DATE 16MAY68  
CHANGE NO. 131287

5.0 PURPOSE:

TO ELIMINATE A PINCH POINT SAFETY HAZARD.

REFERENCE DRAWING

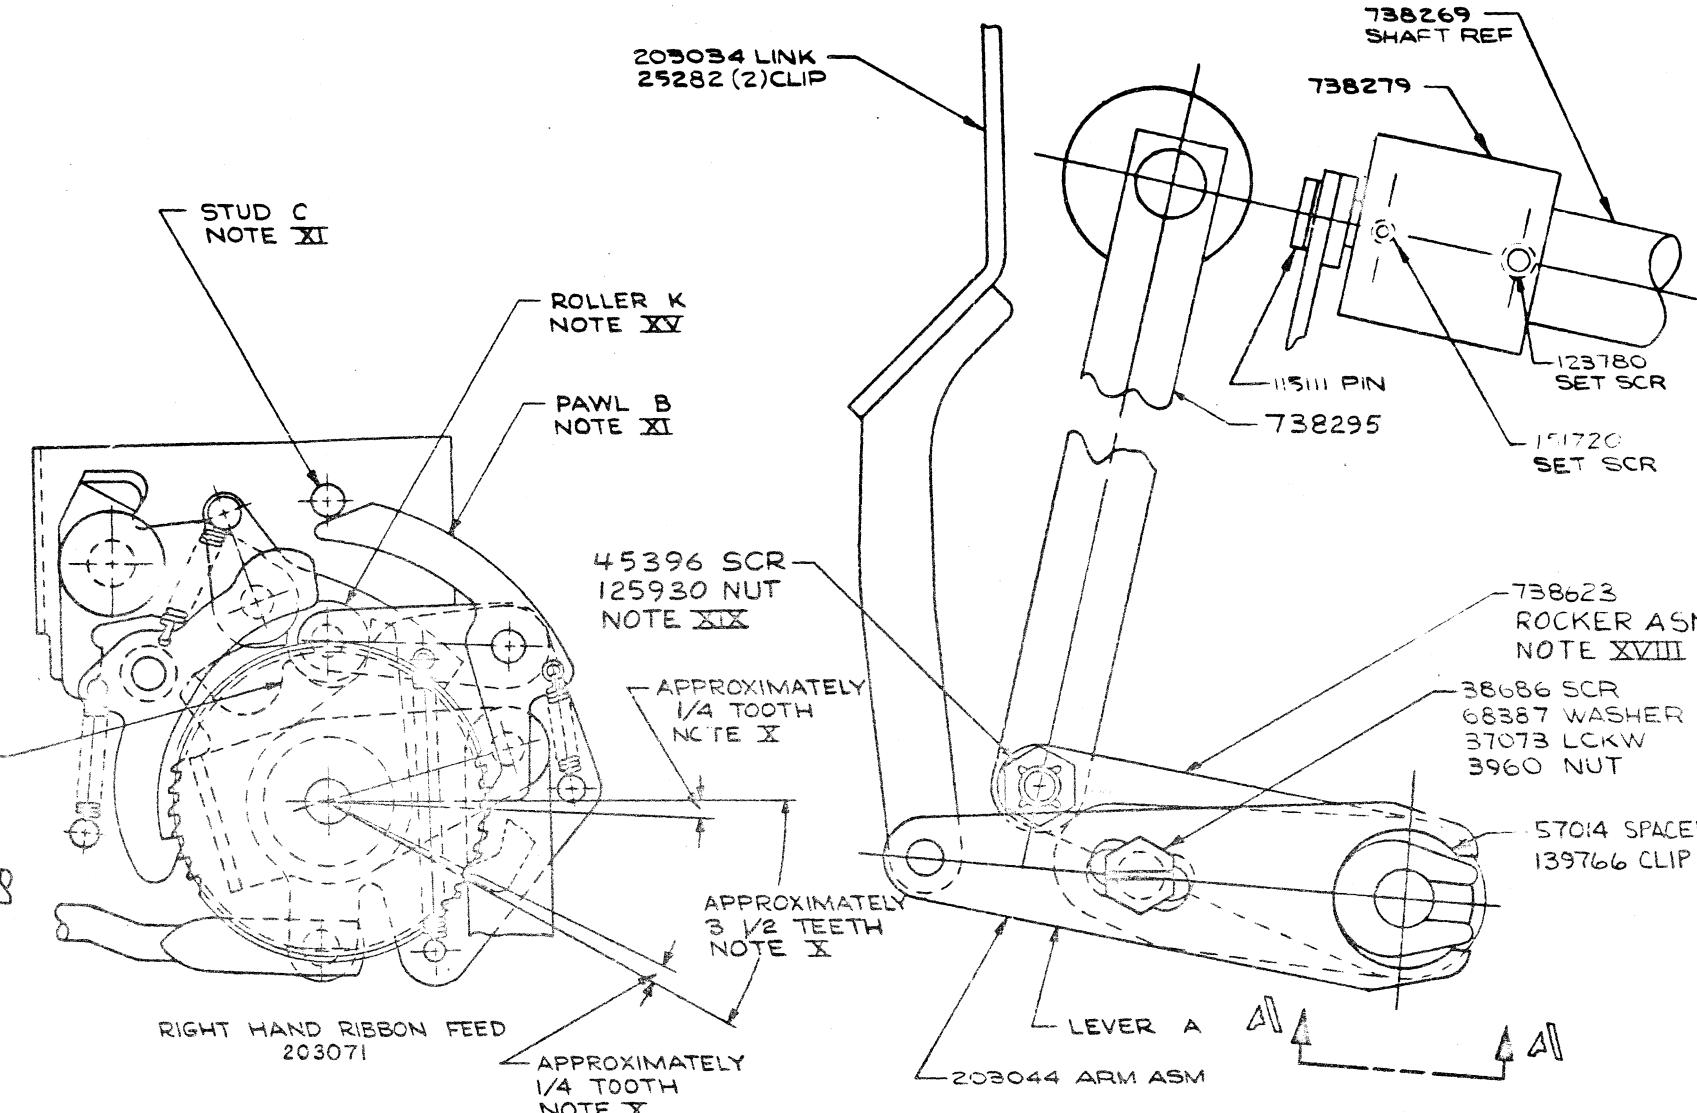
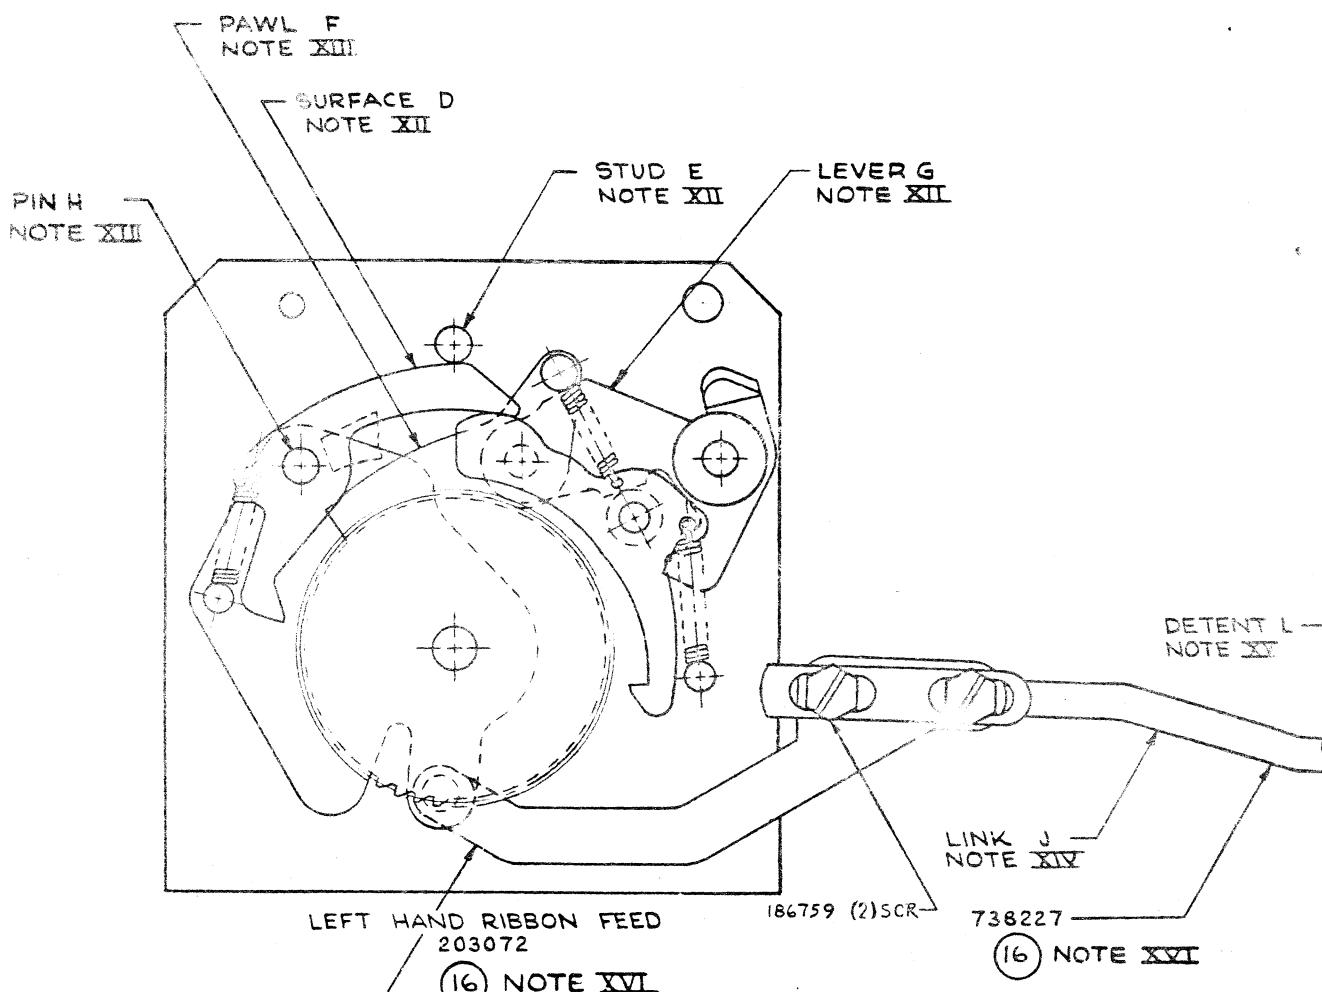
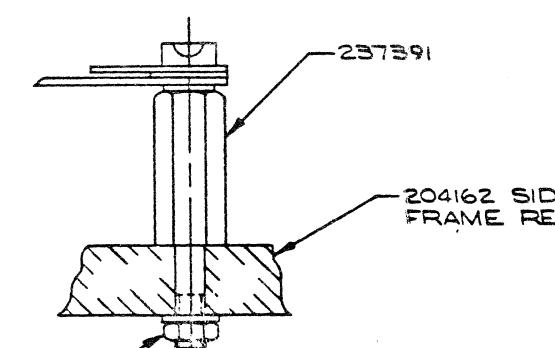
RIBBON FEED TIE ROD LINK ASSEMBLY 223890 AND RIBBON FEED TIE ROD EXTENSION BRACKET 738228 ARE REMOVED AND REPLACED BY NEW RIBBON FEED TIE ROD LINK ASSEMBLY 2532473, THE CONFIGURATION OF WHICH ELIMINATES PINCH POINTS WITH THE DRIVE BELT SAFETY COVER, THE FEED CHECK PAWL SPRING STUD AND THE RIBBON SPOOL.

7.4.1 REFERRING TO REFERENCE DRAWING 738229 PROVIDED, NOTE PAWL F AND STUD E. THE RELATIONSHIP OF THESE PARTS IN THE MACHINE SHOULD APPROXIMATE THAT OF THE DRAWING AND ARE TO BE UTILIZED FOR RE-ASSEMBLY PURPOSES.

7.7 UTILIZING 2 SCREWS REMOVED IN STEP 7.6, ASSEMBLE LOOSELY NEW LINK ASSEMBLY 2532473 AND LINK "J".

7.7.1 CONNECT PIVOT END OF NEW LINK ASSEMBLY TO THE L.H. RIBBON FEED OPERATING ARM UTILIZING LINK ASSEMBLY SPRING CLIP.

7.7.2 HOLDING LINK "J" TO THE FRONT OF THE MACHINE, POSITION LATERALLY THE NEW LINK ASSEMBLY TO SIMULATE ORIGINAL LOCATION OF PAWL F TO STUD E AS NOTED IN STEP 7.4.1. THEN SET MOUNTING SCREWS ACCORDINGLY.
